# Illinois Tollway Standard Drawings Revisions

Section L	Base Sheet Drawings		
	Drawing	Modification Summary Effective: 03-01-2020	
	<b>y</b>		
	L1	Fiber Optic System Typicals and Drawings	
	Sheet 1	Changed 2" to 2" Minimum for the Trenched Conduit Bundles detail

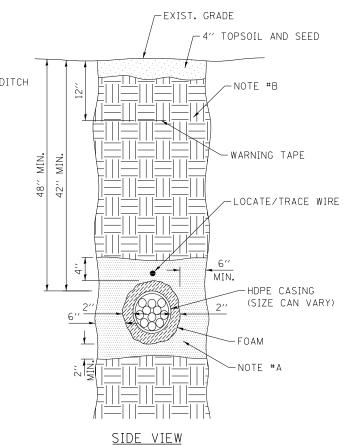
Sheet 2	Changed 2" to 2" Minimum for the Side View detail	
	L2	Fiber Optic Splicing Details	
	Sheet 1	Removed fiber splicing depiction of lateral fiber cable onto the fiber optic backbone cable.	
		Changed the 12 fiber gator patch cable to an 8 fiber gator patch cable.	
		Removed device terminations into Ethernet switch drawing.	
		Removed IE3000 wording from Ethernet switch drawing.	
		Changed title from CCTV & Co-Located Device Cabinet Splicing Details to ITS Cabinet Fiber Connection Details	
		Added note "Contractor shall contact G4S to schedule watch and protect when accessing ISTHA handhole for construction or installing fiber cable".	
		Removed ITS Device Group Fiber Assignments (144 SMFO ITS Communication Cable) table.	
		Added fiber coil note "Leave 100 foot or fiber coil in ISTHA handhole".

# CISCO WS-3850-48T ETHERNET SWITCH 10/100/1000 ETHERNET AND 10G SFP PORT ARRANGEMENT

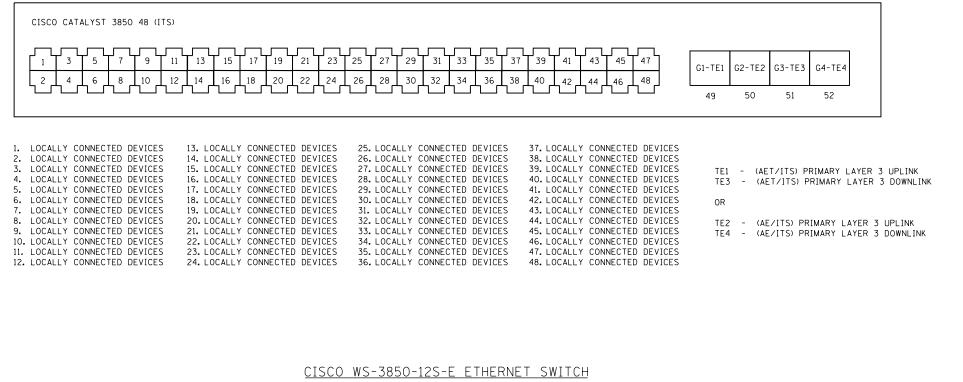
Sheet 2	Removed	
	Sheet 3	Removed	
	Sheet 4	Removed	
	Sheet 5	Removed	
	Sheet 6	Removed	
	Sheet 7	Removed IE3000 wording from Ethernet switch drawing.	
		Removed switch type from Ethernet switch title heading.
